The Commission has issued the enclosed Amendments Nos. 59, 59 and 56 for License Nos. DPR-38, DPR-47 and DPR-55 for the Oconee Nuclear Station, Unit Nos. 1, 2 and 3. These amendments consist of changes to the Station's common Technical Specifications and are in response to your request dated January 23, 1978.

These amendments revise the Oconee Nuclear Station's common Technical Specifications to allow Cycle 4 operation of Oconee Unit No. 1 past 100 effective full power days.

SAFETY EVALUATION BY THE OFFICE OF NUCLEAR REACTOR REGULATION

OCONEE NUCLEAR STATION, UNIT NOS. 1, 2 AND 3

OCONEE 1 CYCLE 4 ROD POSITION
LIMITS FOR FOUR PUMP OPERATION
AFTER 100 ± 10 EFPD

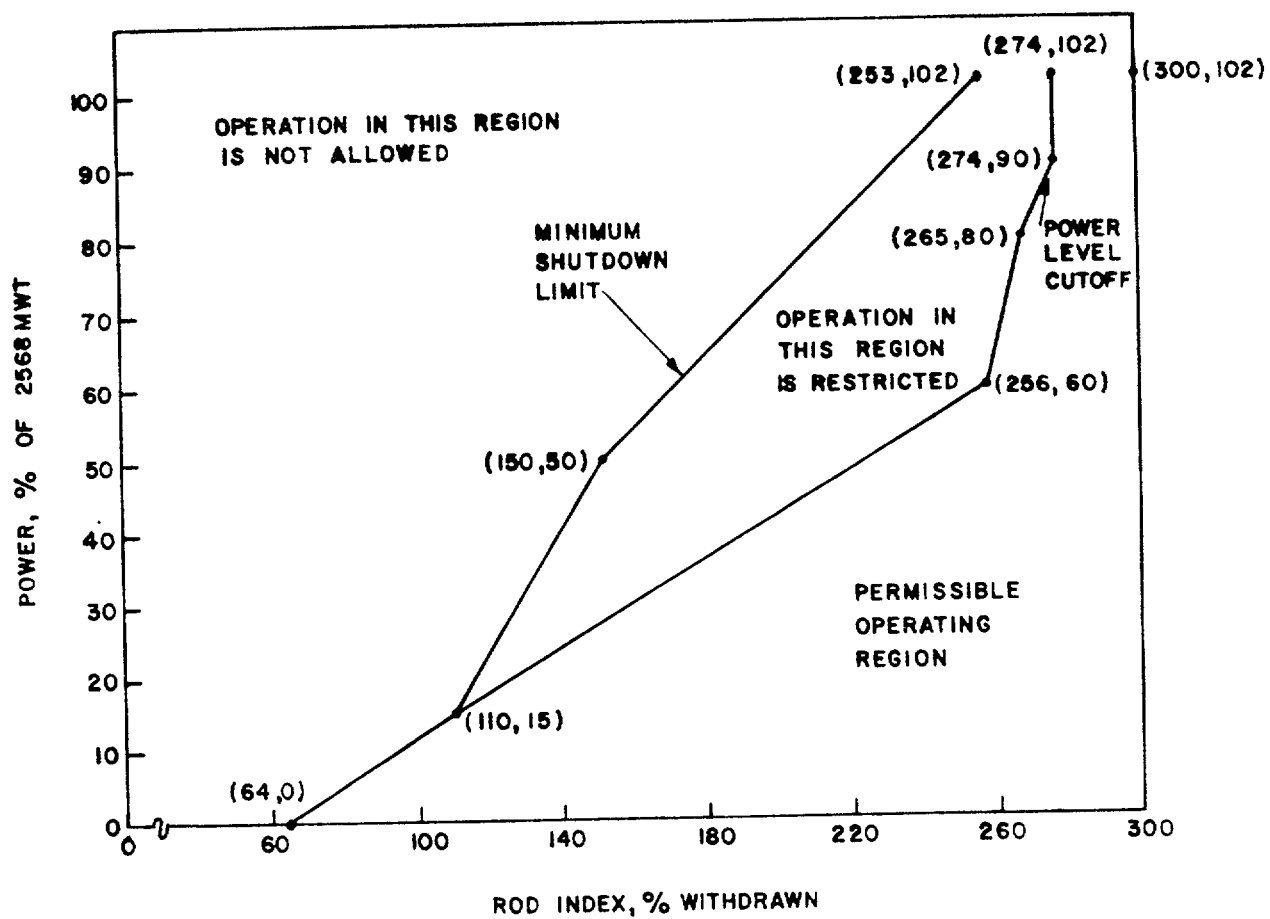
By letter dated January 23, 1978, Duke Power Company (licensee) proposed changes to the Oconee Nuclear Station Technical Specifications.⁽¹⁾ These proposed changes are to the control rod position and axial imbalance limits for operation of Oconee Unit 1 Cycle 4 after $100 \pm$ effective full power days (EFPD) to the end of Cycle 4 (EOC).

By letter dated January 23, 1978, the licensee proposed revised control rod position and axial power imbalance Technical Specifications limits for the period from 100 EFPD to end-of-cycle (EOC). These revised limits considered actual core performance with the tilt. The licensee also presented a discussion and calculation on the possibility that the observed tilt in Cycle 4 could have been caused by a small tilt in Cycle 3 and the cross-core shuffling of once and twice burned fuel for the Cycle 4 design.

Technical Specifications is for the period after 100 effective full power days (EFPD) of operation to EOC. The proposed Technical Specifications have been established with the same calculation models and methods as previously reviewed and found acceptable by us for Oconee 1 Cycle 4. The proposed Technical Specifications would allow continued operation in an unrodded mode (change in rod position limits) with a maximum quadrant tilt of 6.03% (not a change).

OCONEE NUCLEAR STATION
Figure 3.5.2-4A2

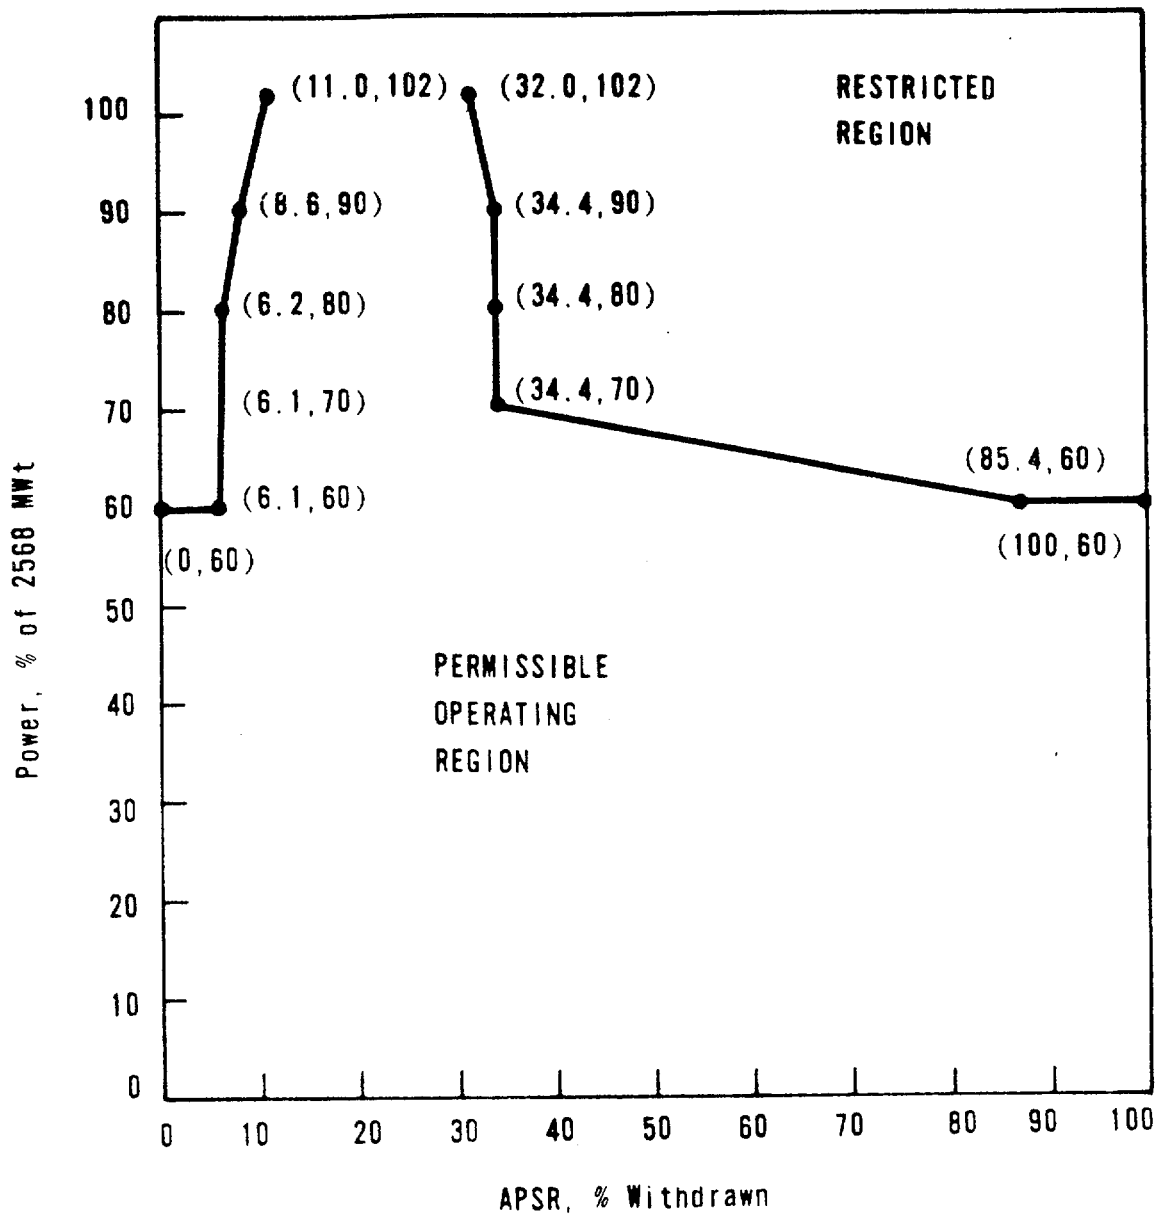
The net effect of all these conservatisms is that the core will be restricted in operating flexibility but allowed to operate at full power in a safe manner. The APSR position limits, Technical Specification Figure 3.5.2 - 4A3, originally approved for operation after 235 $\pm$ 10 EFPD should be observed after 100 $\pm$ 10 EFPD. The imbalance limits that are currently in force for 0 to 100 EFPD are more restrictive than necessary for the proposed mode of rods-out operation from 100 EFPD to EOC, and can thus be retained. This represents another conservatism in the analysis. The rod position limits were determined based on the super-position of the most conservative calculated and measured data. On these bases, the staff finds the proposed changes to the Oconee Unit 1 Technical Specifications to be acceptable.
